Item ID: D206-642-341

Item Name: Replacement Skidtube (Fits LH or RH)

DRAWING NO. D2650	TITLE 206/407 SKIDTUBE ASSEMBLIES	REV. F	DART AEROSPACE LTD ENGINEERING ORDER		D.E.O. NO. D2650-F-1	SHEET NO. SHEET 1 OF 1	SCALE NTS
DRAWN <i>AP</i>	CHECKED <i>A.P.</i>	MFG. APPR. <i>AA</i>	APPROVED <i>AA</i>		DE APPR. <i>AA</i>		
DATE 12.10.12	DATE 12.10.22	DATE 12.10.22	DATE 12.10.22		DATE 12.10.22

CHANGE C'BORED WELDED CROSSBOLT SPACERS TO SWAGED SPACERS

DETAIL G

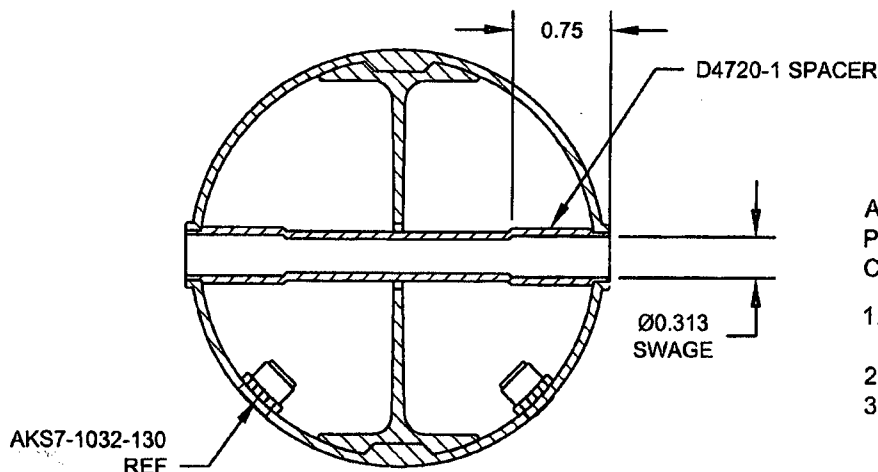
ADD DETAIL G BELOW, WHICH IS THE SAME SECTION VIEW AS DETAIL D OF DWG.

C'BORED HOLES ARE **NOW SWAGED** PER DETAIL G BELOW. FOR THE Ø0.375 HOLE THAT IS NOT C'BORED, WELD PER DETAIL D OF DWG (SEE AMENDED DETAIL B FOR REFERENCE).

D2649 SPACER,
WELD PER DETAIL D OF DWG
BUT DO NOT C'BORE
